The Revised US Geological Survey Floridan Aquifer System (FAS) Framework Study (Williams & Kuniansky, 2015): Potential Issues for Florida's Water Regulators

On April 21, 2015 the United States Geological Survey (USGS) released a report entitled: Revised hydrogeologic framework of the Floridan aquifer system (FAS) in Florida and parts of Georgia, Alabama and South Carolina. The report was authored by USGS geologists Lester Williams and Eve Kuniansky. This report is an update to the 1986 USGS Professional Paper 1403-B, authored by USGS geologist Jim Miller, which defined the hydrogeologic framework of the FAS. Miller's report has served as the foundation upon which water managers and hydrogeologists in Florida built the current regulatory and management schemes. It also allowed geologists and hydrologists to communicate with one another using a standardized nomenclature. As more geologic and hydrogeologic data have accumulated since Miller's 1986 report, it became necessary to revise the FAS framework. However, this 2015 revision has the potential to cause some issues within various state regulatory agencies that have relied upon the old framework. The authors of the revised report

Figures below illustrate how the new FAS framework is different from currently used framework in central Florida:

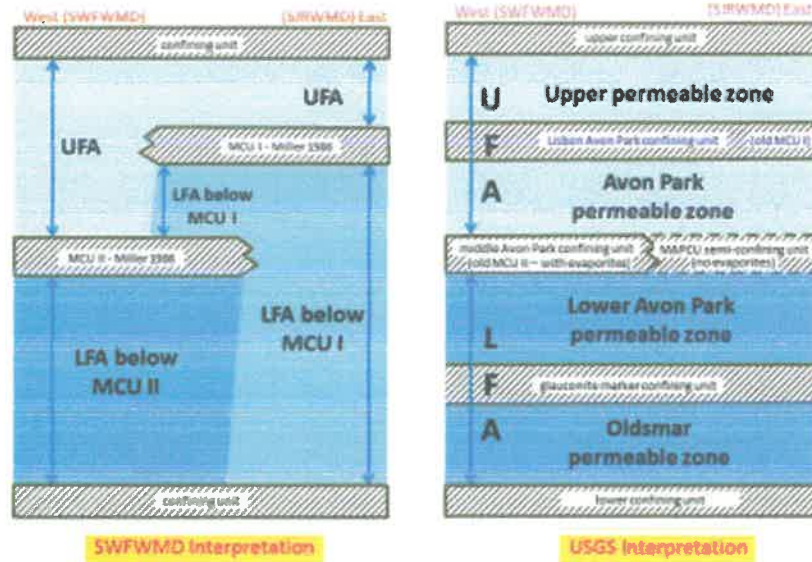
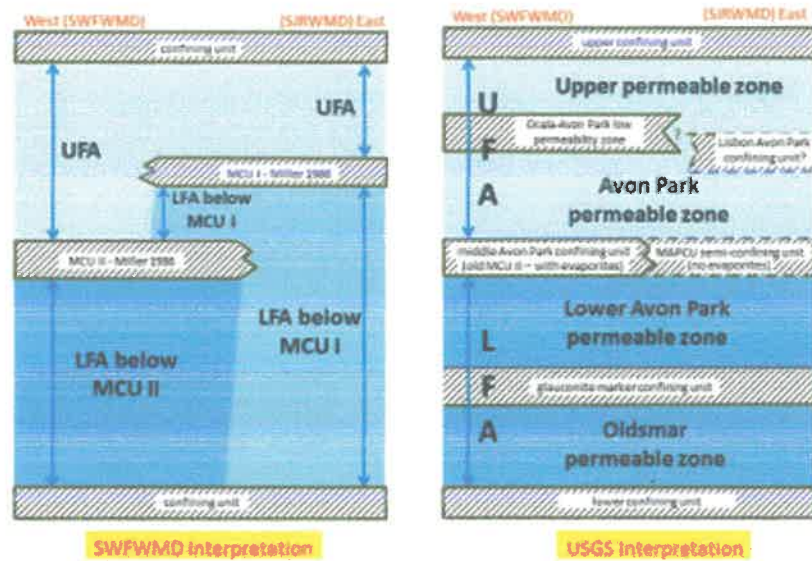
- Existing middle confining units I-VII of the Floridan aquifer system by Miller (1986) have been abandoned, remapped, or re-assigned, to a newly introduced ambiguous 'composite unit' that does not conform to established USGS and other aquifer nomenclature guidelines. From the abstract: *"Although the term "confining unit" is not totally abandoned within the revised framework, a new term "composite unit" is introduced for lithostratigraphic units that cannot be defined as either a confining or aquifer unit over their entire extent."*

- If it can't be defined as an aquifer or confining unit, it is fundamentally not a hydrostratigraphic unit
 - Lithostratigraphic units should not be defined by hydrostratigraphic units; boundaries of each are independent of the other

- You can't make up your own new units without due diligence to published literature and existing hierarchy
 - Lumping all MCUs with different origins, lithologies, elevations, and hydraulic characteristics (as Miller delineated and our data supports) into a single composite unit seems to be a de-evolution of our understanding of the true system

- There was nothing wrong (or incorrect) with Miller's delineation of the discontinuous sub-regional MCUs. This represents reality we see in data, and is not difficult for people to conceptualize

- This new framework seems to blur the true structure of the MCUs, and then over-complicate the aquifers with ambiguous 'zonation' terminology. It also needlessly and redundantly identifies permeable zones of aquifers.

- So basically this new unit can be a confining unit, a semi-confining, or even an aquifer?
 - Confining unit boundaries appear to extend past actual confinement so they follow rock-strata that can be mapped easier with geophysical markers and without abrupt structural changes? (which actually do exist).

- This report violates hydrostratigraphic fundamentals by delineating major confining units that divide aquifers into upper and lower zones of the same aquifer, for instance, the UFA (Lisbon-Avon Park confining unit) and in the LFA (Glauconite confining unit). This cannot be. Confining units 'confine', meaning they cause different heads in the permeable rocks above and below them = different aquifers. You can't pass through a confining unit (like MCU_I) and still be in the UFA.
